UNITED STATES OF AMERICA
BEFORE THE
FEDERAL ENERGY REGULATORY COMMISSION

PETITION OF THE
NORTH AMERICAN ELECTRIC RELIABILITY CORPORATION
FOR APPROVAL OF
PROPOSED RELIABILITY STANDARD CIP-012-2

Figure 3

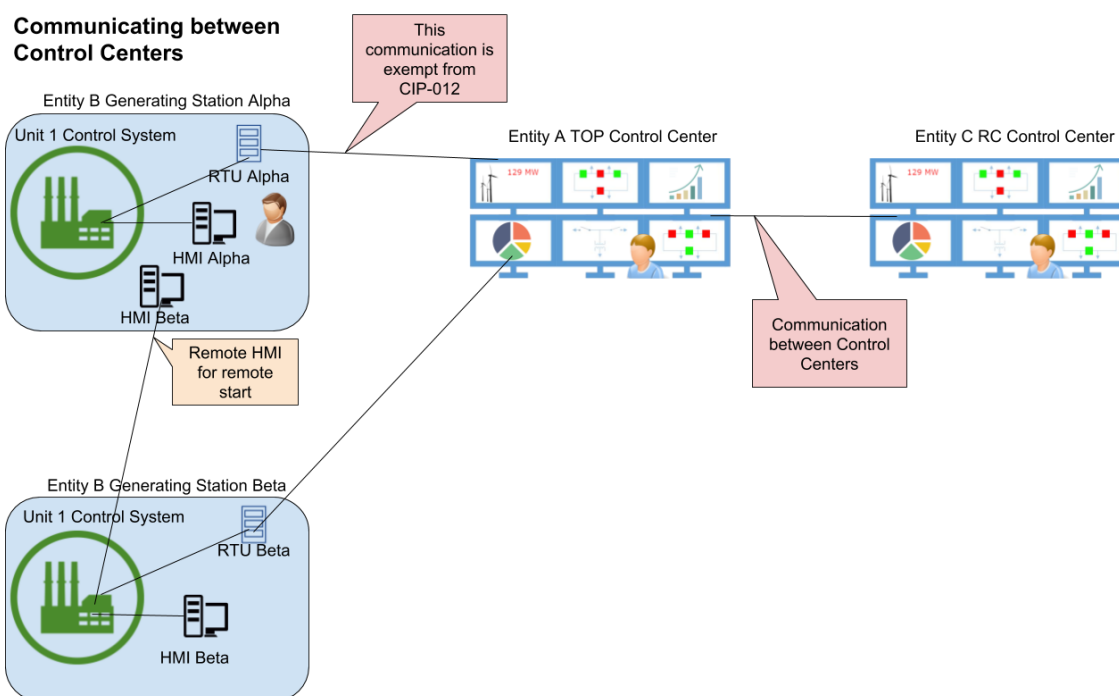
Reclamation also recommends the SDT review the paragraph under CIP-012 Technical Rationale Figure 3. "Station Alpha and Entity A's TOP Control Center subject to CIP-012 without the exemption" does not align with the description in Figure 3 that states, "This communication is exempt from CIP-012."

Reclamation also recommends the SDT review the paragraph under CIP-012 Technical Rationale Figure 3. “Station Alpha and Entity A’s TOP Control Center subject to CIP-012 without the exemption” does not align with the description in Figure 3 that states, “This communication is exempt from CIP-012.”

Although nothing has changed between them, this proximity (without the exemption preventing it), ~~makes-would make~~ the communication noted in Figure 3 between Station Alpha and Entity A's TOP Control Center subject to CIP-012 ~~without the exemption~~. Two HMIs have been moved into the same room and a new NERC CIP ~~s~~Standard applies to two entities. Because of exemption 4.2.3, the communication is out of scope of CIP-012.
